Modification of Tool Kit 91-806563A1 for D-Tronic Diesels

Models

MCM/MIE D2.8L D-Tronic

MCM/MIE D4.2L D-Tronic

12 MM TRIPLE SQUARE TOOL

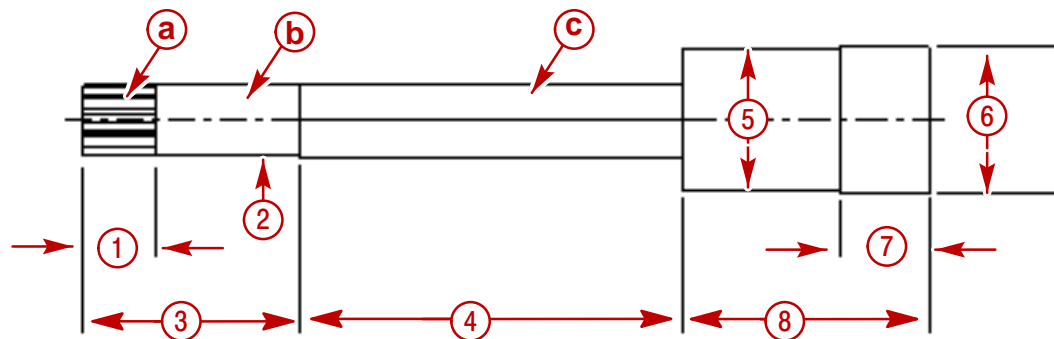
The required 100 hour re-torque of the cylinder head bolts on the above listed engines require the removal of the oil feed line to the rocker arms to fit the torque tool on the 12 mm triple square bolts. The 12mm tool can be modified so that this oil line can stay in place during this procedure. Using the drawing below, make the modifications to the existing 12 mm tool. After modification the tool can still be used on the D3.0L, D3.6L and D4.2L engines, with triple square head bolts.

- a** - 12 Point Triple Square
- b** - Modified Area
- c** - 0.5 (12.8 mm) Across Flats Hex
- 1** - 0.50 in. (12.8 mm)
- 2** - \varnothing 0.47 (11.9 mm)
- 3** - 1.48 (37.6 mm)
- 4** - 2.62 (66.6 mm)
- 5** - \varnothing 0.96 (24.4 mm)
- 6** - \varnothing 0.99 (25.2 mm)
- 7** - 0.60 (15.2 mm)
- 8** - 1.68 (42.7 mm)
